Access Compliance Report

Public Rights-of-Way

(Pedestrian Signals)

Intersection ID: N/A	Main Street:	Cross Street: N/A	Location: N/A
ADA ID: BFCC7F00701F	Signal Type: One Push Button-APS	Overall Compliance: No	Severity Score: BTN 1: N/A BTN 2: N/A No BTN: N/A
Codes/Mitigation Info/Possible Solution		Field Measurements/Component Compliance

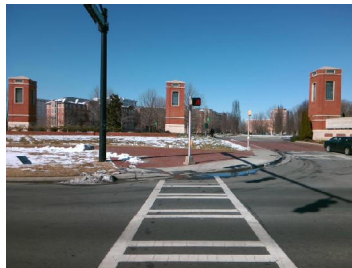
Compliance	Description	Data	Compliance	Description	Data
	Button Count	Button1	Yes	Distant to Additional Button (in)	488.0
	Additional Button Present?	Yes		Additional Button ID	3957ADA5E254
N/A	Signal Buttons Required?	N/A	N/A	Additional Ped Posts Required	N/A
	How Many Ped Street Xings?	N/A		Located In An Island/Median?	N/A
N/A	B 1 Sign Present?	Yes	N/A	B 2 Sign Present?	N/A
Yes	B 1 Sign Purpose?	Yes	N/A	B 2 Sign Purpose?	N/A
Yes	B 1 Sign Lettering & Contrast?	Yes	N/A	B 2 Sign Lettering & Contrast?	N/A
Yes	B 1 Parallel To XWalk?	Yes	N/A	B 2 Parallel To XWalk?	N/A
Yes	B 1 PAR to Button?	Yes	N/A	B 2 PAR to Button?	N/A
Yes	B 1 PAR to XWalk?	Yes	N/A	B 2 PAR to XWalk?	N/A
Yes	B 1 Clear Floor Space?	Yes	N/A	B 2 Clear Floor Space?	N/A
N/A	B 1 FWD Approach?	Yes	N/A	B 2 FWD Approach?	N/A
N/A	B 1 FWD Approach Constrained?	Yes	N/A	B 2 FWD Approach Constrained?	N/A
No	B 1 FWD Approach Reach (in)	5.0	N/A	B 2 FWD Approach Reach (in)	N/A

Yes	B 1 FWD Approach Width (in)	48.0	N/A	B 2 FWD Approach Width (in)	N/A
N/A	B 1 FWD Approach Obstruction?	Yes	N/A	B 2 FWD Approach Obstruction?	N/A
N/A	B 1 FWD Approach Obstruction Dist (in)	4.0	N/A	B 2 FWD Approach ObstructionDist (in)	N/A
N/A	B 1 PARA Approach?	Yes	N/A	B 2 PARA Approach?	N/A
N/A	B 1 PARA Approach Constrained?	Yes	N/A	B 2 PARA Approach Constrained?	N/A
Yes	B 1 PARA Approach Reach (in)	5.0	N/A	B 2 PARA Approach Reach (in)	N/A
No	B 1 PARA Approach Width (in)	48.0	N/A	B 2 PARA Approach Width (in)	N/A
N/A	B 1 PARA Approach Obstruction?	Yes	N/A	B 2 PARA Approach Obstruction?	N/A
N/A	B 1 PARA Approach Obstruction Dist (in)	4.0	N/A	B 2 PARA Approach ObstructionDist (in)	N/A
No	B 1 Clear Floor Space Slope (%)	5.1	N/A	B 2 Clear Floor Space Slope (%)	N/A
No	B 1 Clear Floor Space XSlope (%)	2.8	N/A	B 2 Clear Floor Space XSlope (%)	N/A
N/A	B 1 PAR Slope (%)	N/A	N/A	B 2 PAR Slope (%)	N/A
Yes	B 1 Height (in)	38.0	N/A	B 2 Height (in)	N/A

N/A	B 1 Clear Xing Direction?	Yes	N/A	B 2 Clear Xing Direction?	N/A
	B 1 Crossing Direction	To SE		B 2 Crossing Direction	N/A
Yes	B 1 DistanceTo XWalk (in)	0.0	N/A	B 2 DistanceTo XWalk (in)	N/A
No	B 1 DistanceTo Curb (in)	74.0	N/A	B 2 DistanceTo Curb (in)	N/A
Yes	B 1 Diameter (in)	2.0	N/A	B 2 Diameter (in)	N/A

Possible Solutions: Replace Signal Push Button With APS Button on New Post. Remove & Relocate Sign.
